MEMORANDUM

SUBJECT: Request approval (1) to award the SWL 337 development opportunity to Seawall Lot 337 Associates, LLC and (2) to authorize exclusive negotiations for a mixed-use development project at SWL 337 and Pier 48 bounded by China Basin Channel, Third Street, Mission Rock Street, and San Francisco Bay.

The Print Covers Calendar Item No. 11A

Neighborhood Character, Historic Resources & City Form

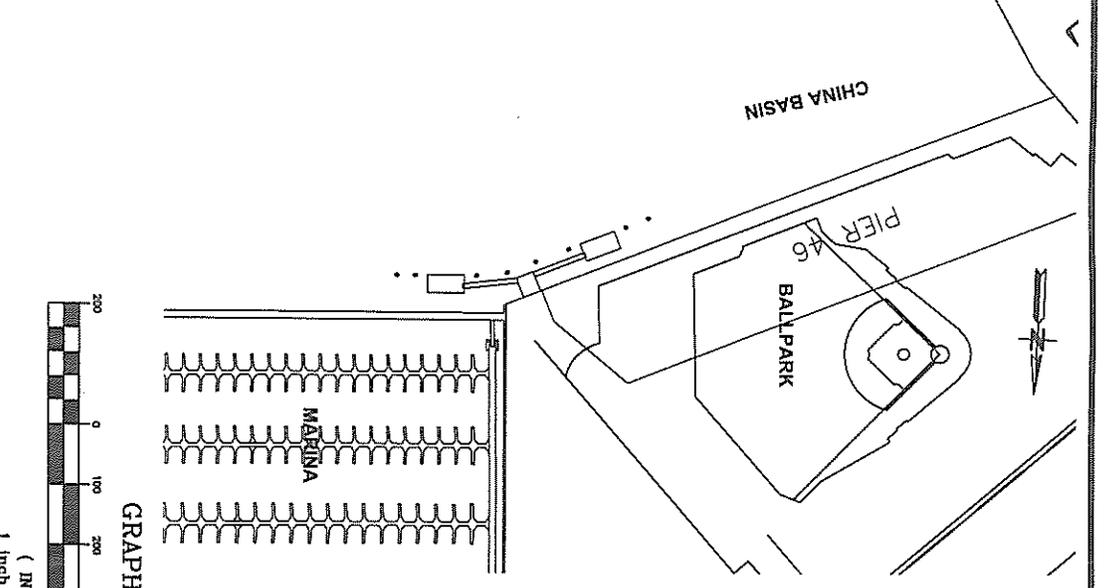
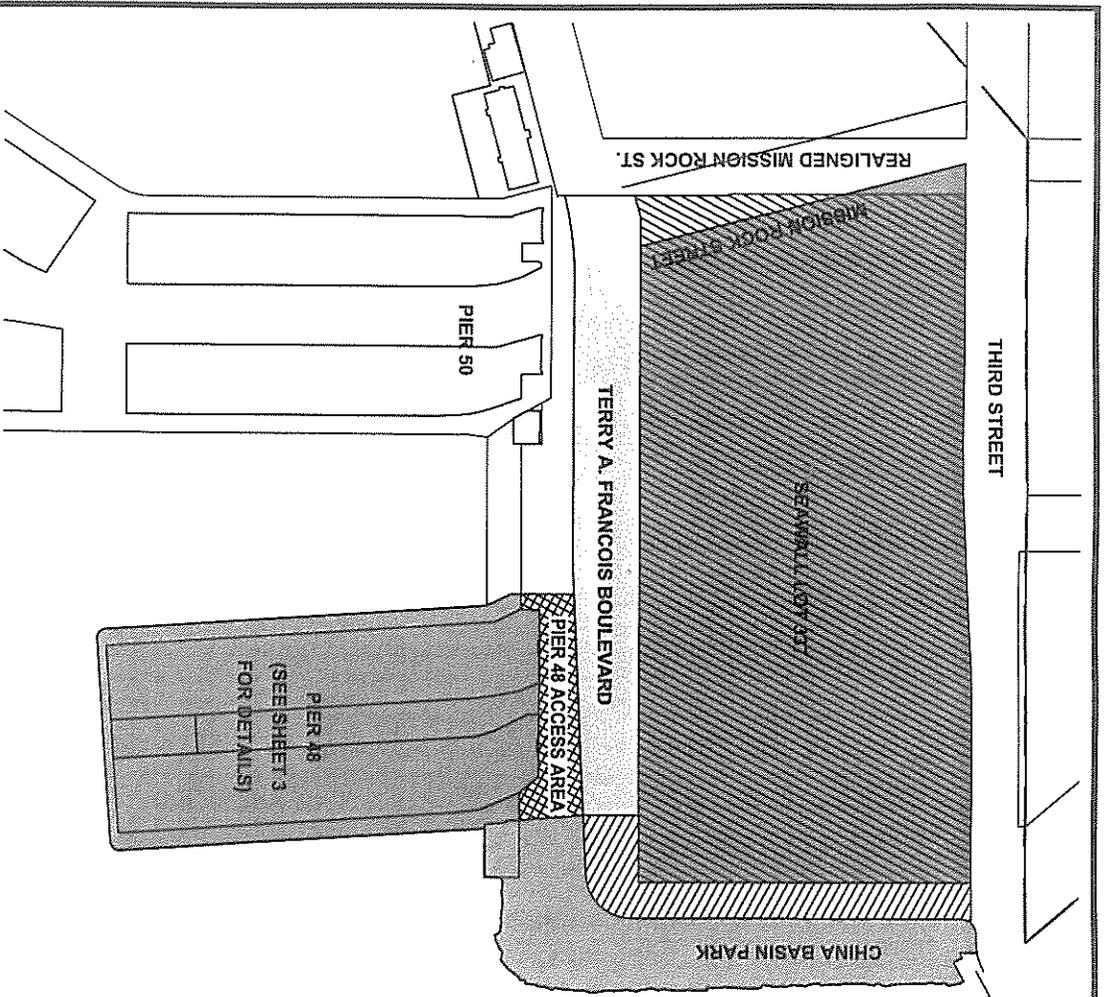
1. Produce a site plan which identifies the locations, heights and building mass dimensions of the proposed development program.
2. Demonstrate that development orientation and design actively contribute to an inviting, pedestrian character of publicly-accessible open spaces, and avoid creating adverse microclimate conditions.
3. Incorporate architectural and urban design treatments in perimeter blocks to acknowledge and relate to the surrounding Mission Bay area, as well as integrate with activities and built elements internal to the project.
